Request for Additional Information
Model No. Traveller
Docket No. 71-9297

By application dated April 1, 2004, Westinghouse Electric Company requested a Certificate of Compliance for the Model No. Traveller package. This request identifies additional information needed by the Nuclear Regulatory Commission staff (the staff) in connection with its review of the safety analysis report (SAR). The requested information is listed by chapter number and title in the SAR. NUREG-1609, "Standard Review Plan for Transportation Packages for Radioactive Material," was used for this review. This request describes information needed by the staff for it to complete its review of the SAR and to determine whether the applicant has demonstrated compliance with regulatory requirements.

Figure 2-23 Bolt FE Models

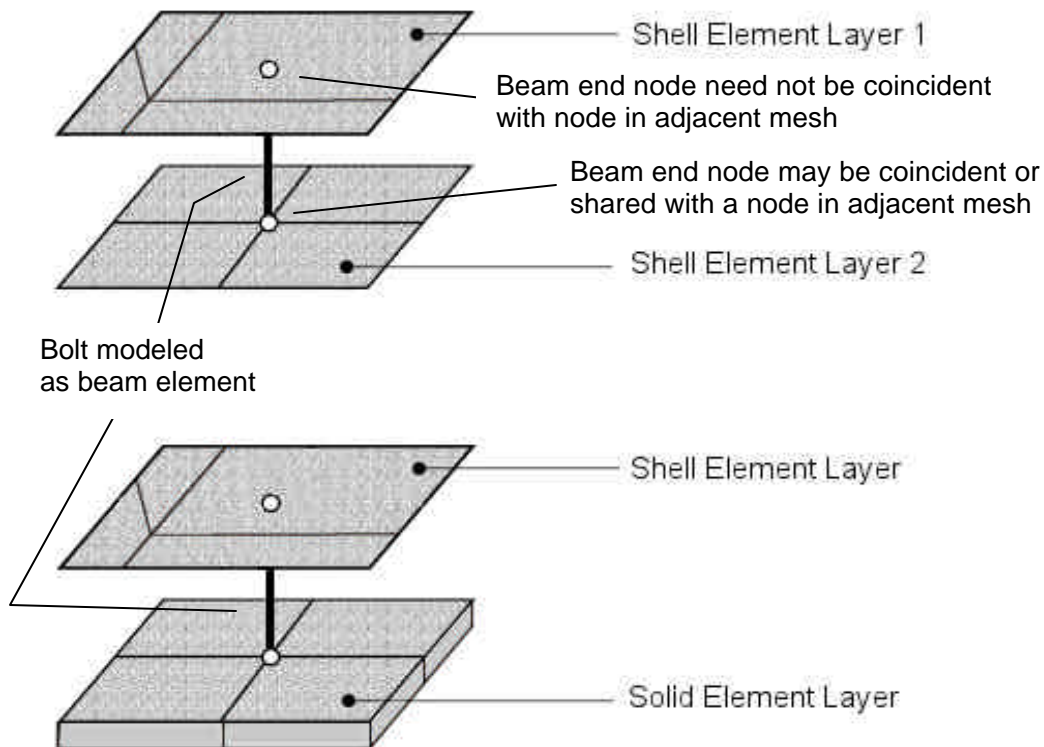
2-23 Provide a description of the finite element models used for calculating bolt axial and shear forces, Table 2-26. For the resulting forces, justify the basis for using the ultimate strengths in the interaction equation evaluation of factors of safety for the bolts subject to concurrent tensile and bi-axial shear forces. It is not clear from the information provided whether the bolts were allowed to yield in the finite element analysis of the drop accident, which could markedly affect the calculated bolt forces. The staff notes that bolt interaction equations generally do not lend themselves to an evaluation involving material ultimate strengths.

A schematic of the finite element bolt model is shown in Figure 2-23. This is representative of all bolts used in the shipping package. It consists of a 3D beam element whose end nodes are in the plane of the layers being joined by the bolt. The end nodes are attached to the shell or solid elements either by being shared or by being tied using a penalty-based constraint.

Bolt material was modeled as steel with isotropic hardening. Thus, the bolts are indeed allowed to yield and still function until the criteria shown in the bolt interaction equation (equation H-2 in

Figure 2-95 Impact Limiter in Prototype Unit Model

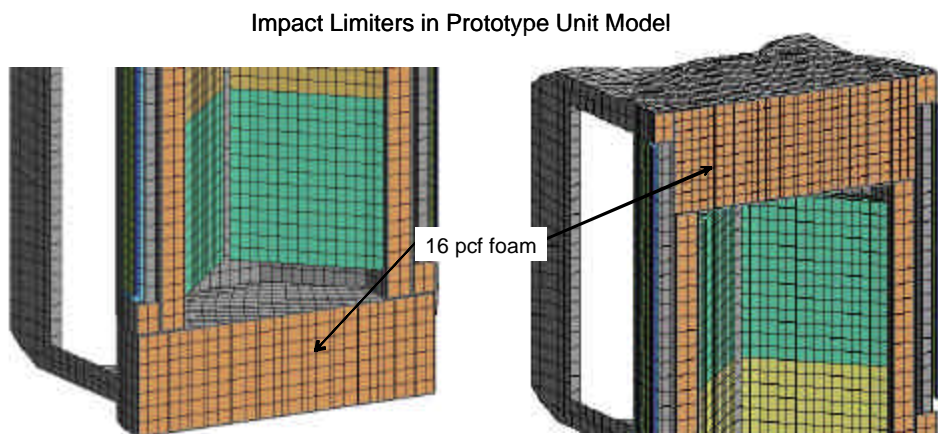
- 2-25 Provide a discussion clarifying the apparent discrepancy between the statement provided on page 2-148, “[t]he prototype packages employed 11 pcf foam along the axial section of the package and 16 pcf foam in the endcaps,” and the information provided in Figures 2-95 and 2-112 which indicate that the end cap for the Prototype Test Unit was filled with the 11 pcf, rather than the 16 pcf, foam.

The following figure, Figure 2-95, has been replaced:

Figure 2-91 Predicted and Measured Y Accelerations

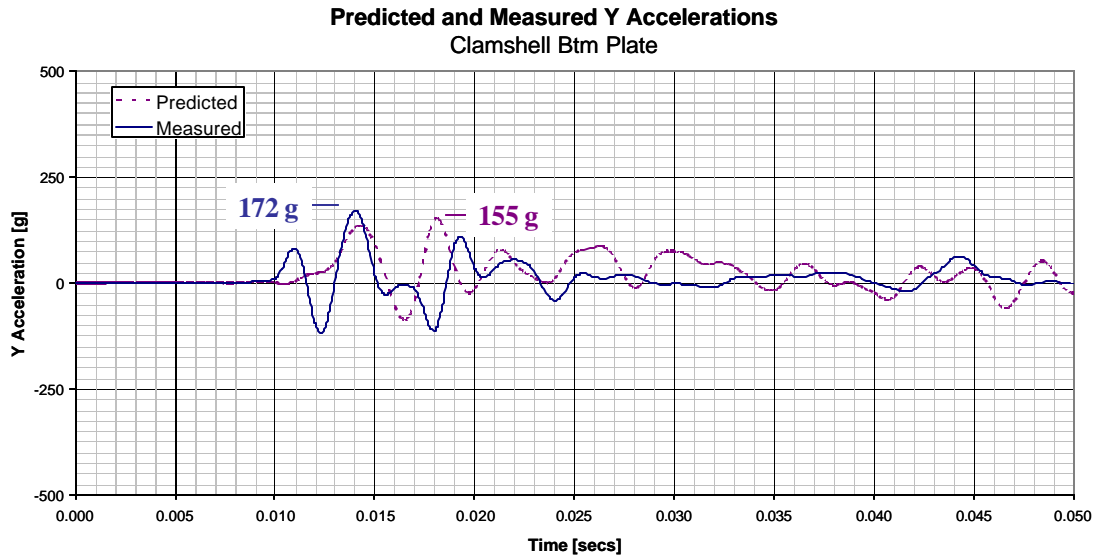
- 2-27 Provide a discussion explaining the apparent discrepancy between the measured vertical decelerations of 191 g in Table 2-30 and 205 g in Figure 2-91.

The following figure, Figure 2-91, has been replaced:

Figure 2-129 Drop Orientation for QTU Test Series 1

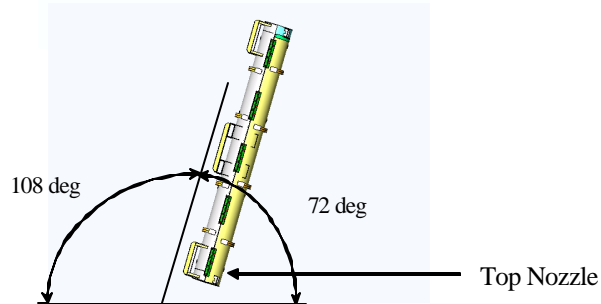
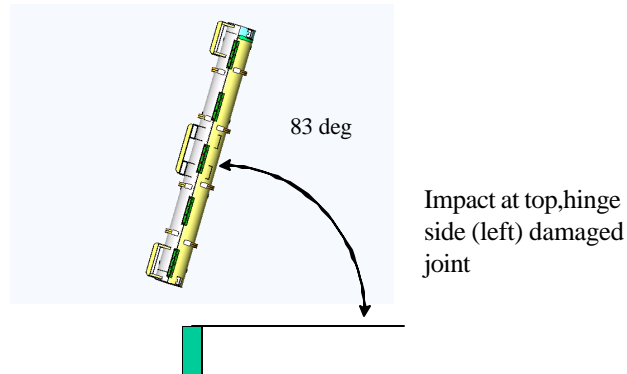
2-28 Provide a discussion clarifying the drop angle/orientation depictions of Test 1.2 and Test 1.3 in Figure 2-129 for the respective CG-Over-Corner and pin puncture tests. It is not clear how the drop angle of 108° was defined for Test 1.2. The puncture drop of Test 1.3 does not appear to have the package hinge side of the Outerpack land on the puncture pin as described in the text.

The following text has been added to Section 2.12.4.2.1 and Figure 2-129 has been replaced:

Figure 3-27A Orientation of CTU for Thermal Test

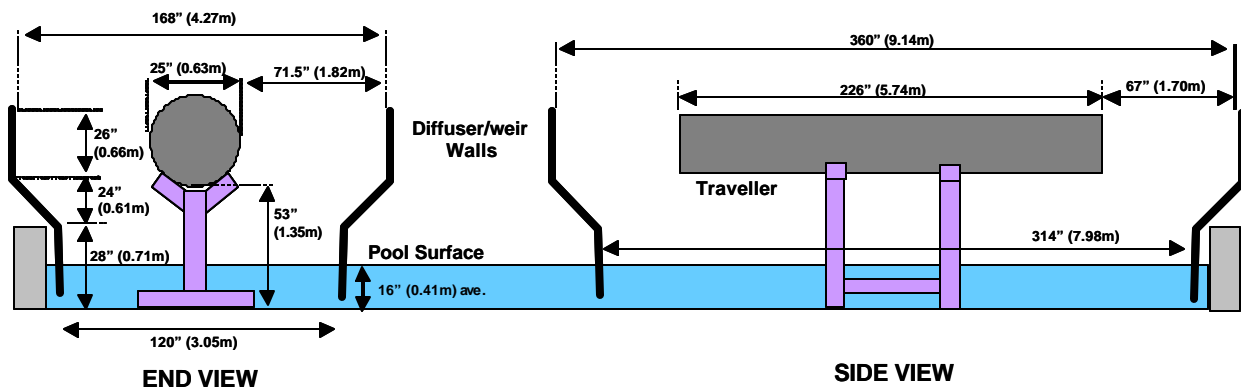
- 3-1 Revise the SAR to specify the orientation of the certified test unit (CTU) with regard to the fire test pool. Specifically, state the distance the bottom of the package was positioned above the fire pool surface and the distance the pool extended beyond the ends of the package.

The following text and figure have been added to Section 3.6.4:

Figure 3-27A shows the orientation of the Certification Test Unit (CTU) for the thermal test. The bottom of the package was positioned approximately 1 meter from the top of the fire pool surface. The distance of the outer facility walls beyond the edge of the package were 67" at the ends and 71.5" at the sides.
